# HERBATA DATA CENTRE, NAAS - RESPONSE TO REQUEST FOR FURTHER INFORMATION ("RESPONSE TO RFI") FROM KILDARE COUNTY COUNCIL

## ADDENDUM TO CHAPTER 4 DESCRIPTION OF THE PROJECT AND NEED FOR THE PROJECT

NI2615  
01  
June 2025

Figure 4.10: Locations of Mammal Passes in Palisade Security Fencing (extract of now submitted drawing BSM-ZZ-ZZ-DR-L-0311)

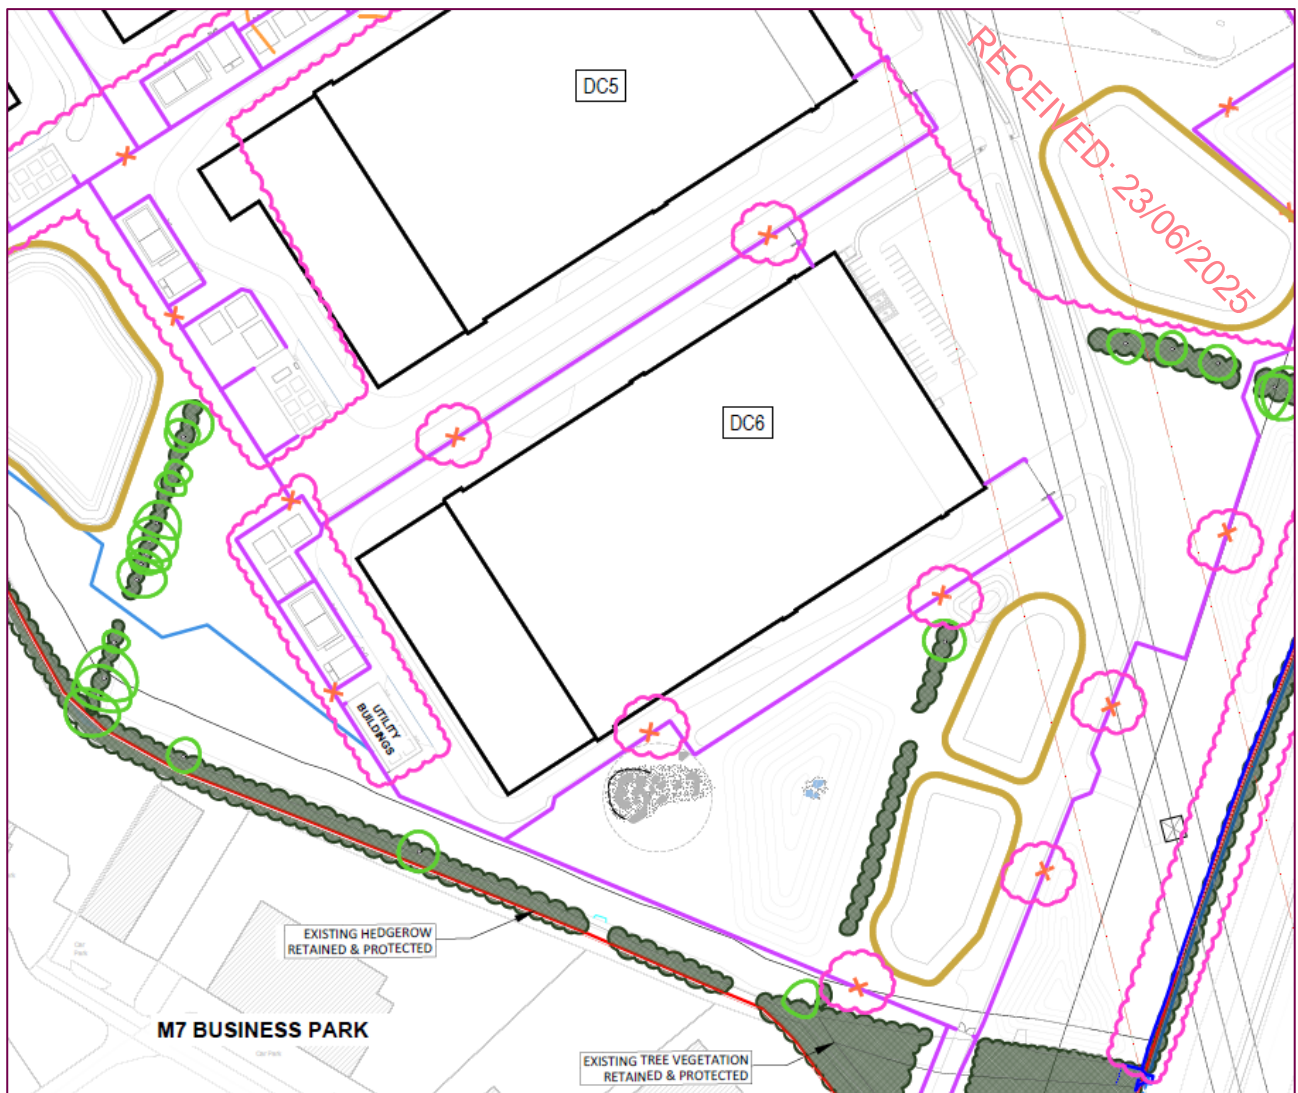
In consideration of the request for inclusion of a fencing arrangement *to allow for wildlife access and passage through the site*, an amendment has been made to the proposed Landscape Masterplan to include mammal passes in fences throughout the full extent of the site. The number, location and dimensions of the mammal passes was established following engagement between the project ecology and landscape team. The inclusion of the mammal passes has not required changes to the submitted landscape planting proposals.

Mammal passes are proposed at locations throughout the site including all *perimeter* fences and *internal* fences within the site (for example around each Data Centre building). A gap at the foot of the proposed fencing, of 500mm (width) x 200mm is determined sufficient for all potential mammal species and should ensure access and passage throughout the site. There are no proposed amendments to the overall height, materials or layout of the proposed fencing.

Figure 4.13: Amended Construction Phase Layout (extract from now submitted Updated CTMP, Volume II, Appendix 4.6)

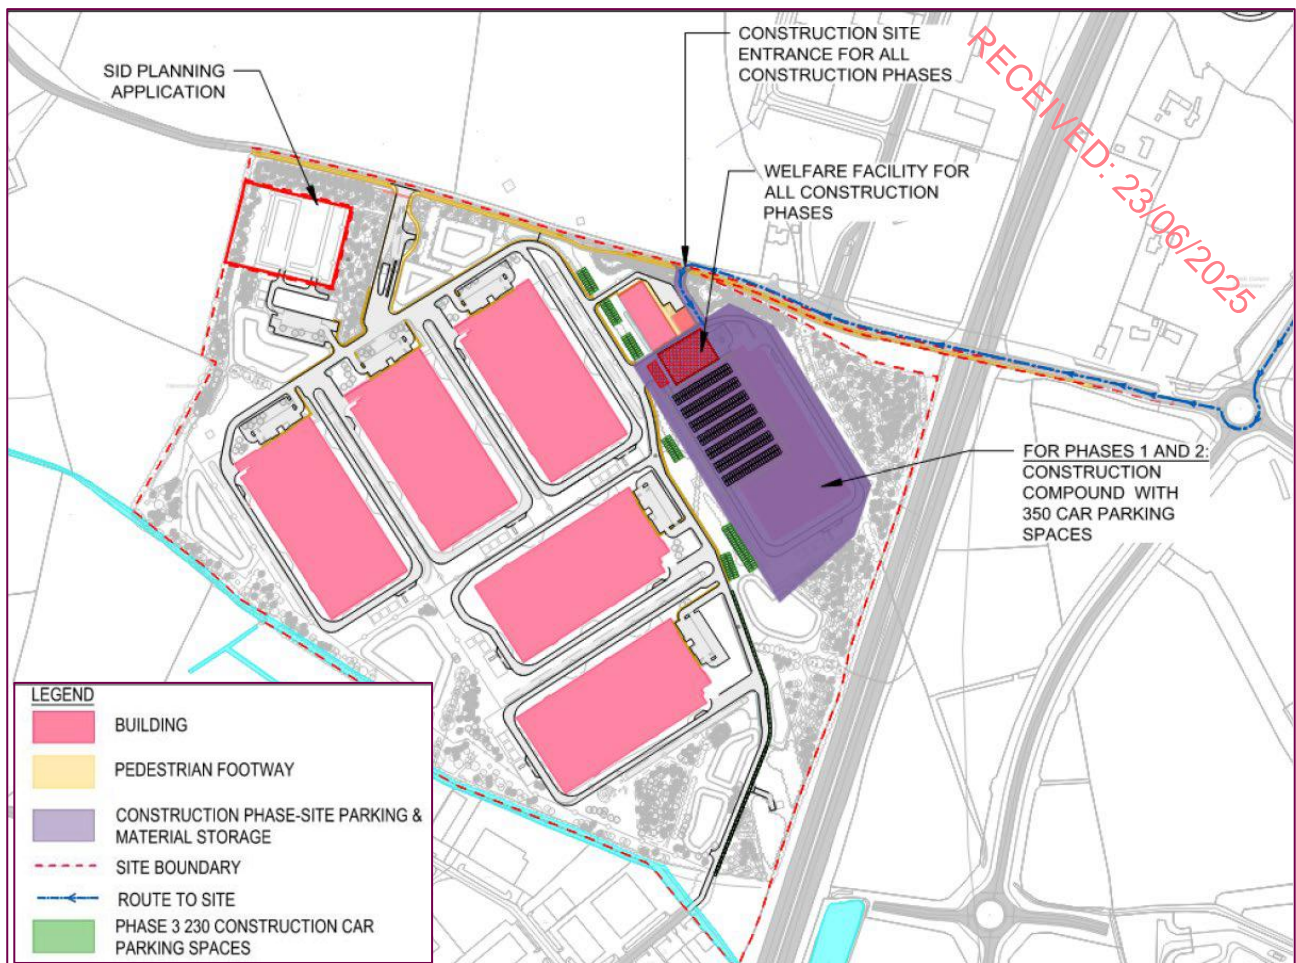
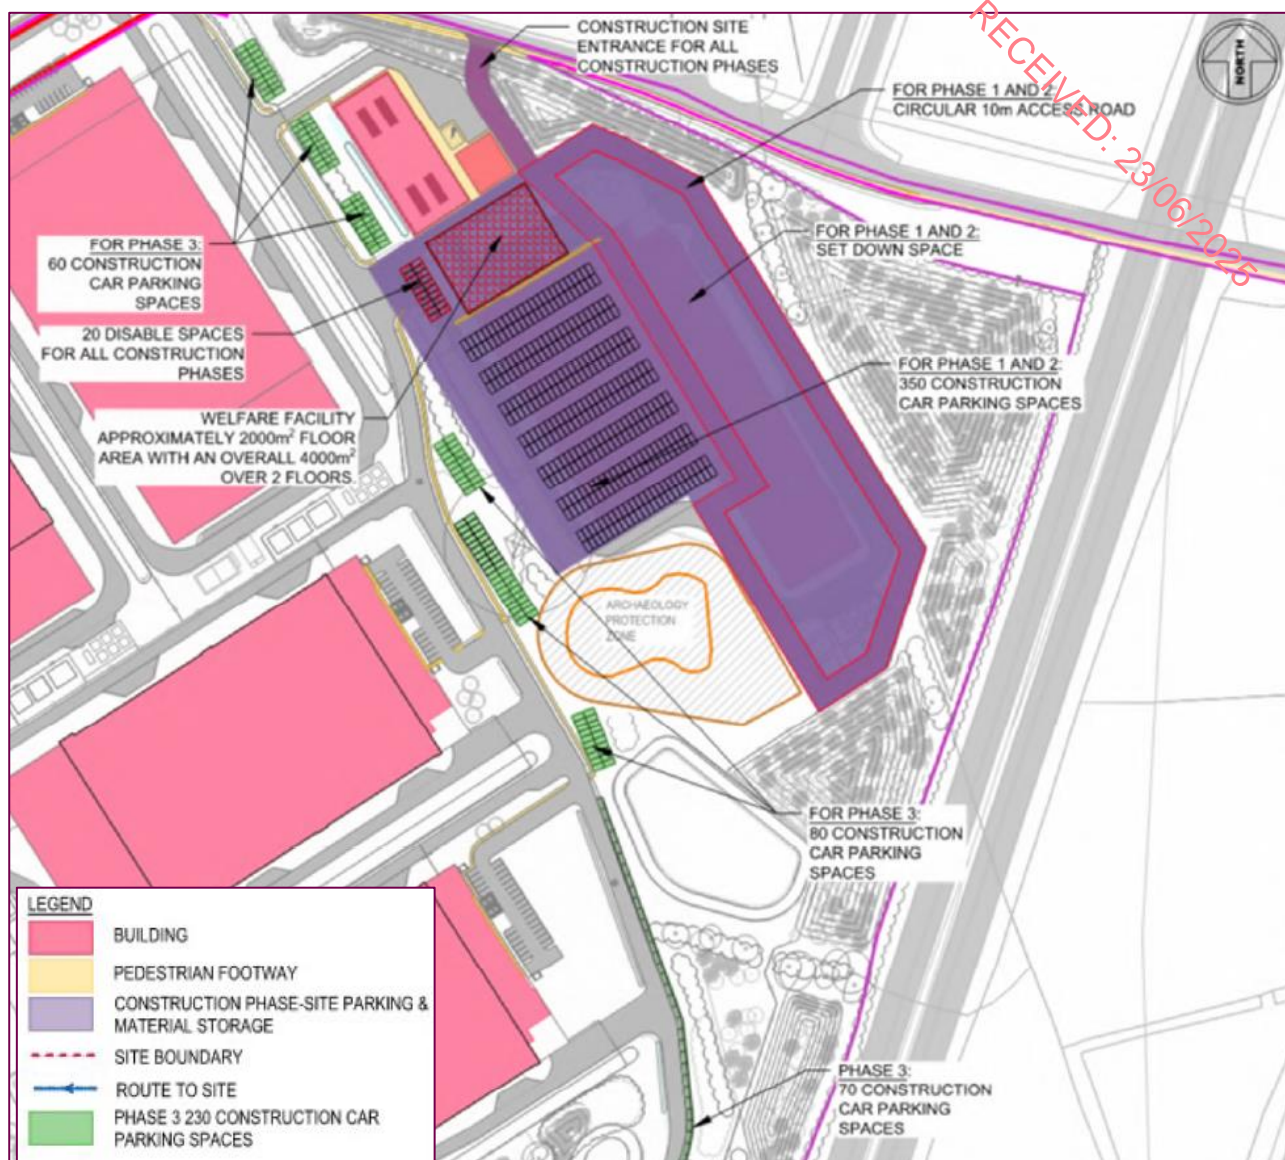
Whilst the proposed site phasing remains consistent with that set out within the submitted EIAR, the amended design for Data Centre 4 has necessitated an amendment to the construction compound (parking and material storage) in the vicinity of Data Centre 4.

For the purpose of comparison, Figures 4.12 and 4.13 below, illustrate the previously submitted layout detail for Data Centre 4 and (amended) proposed layout detail for Data Centre 4 respectively as set out in the now submitted Updated CTMP (Volume II, Appendix 4.6).
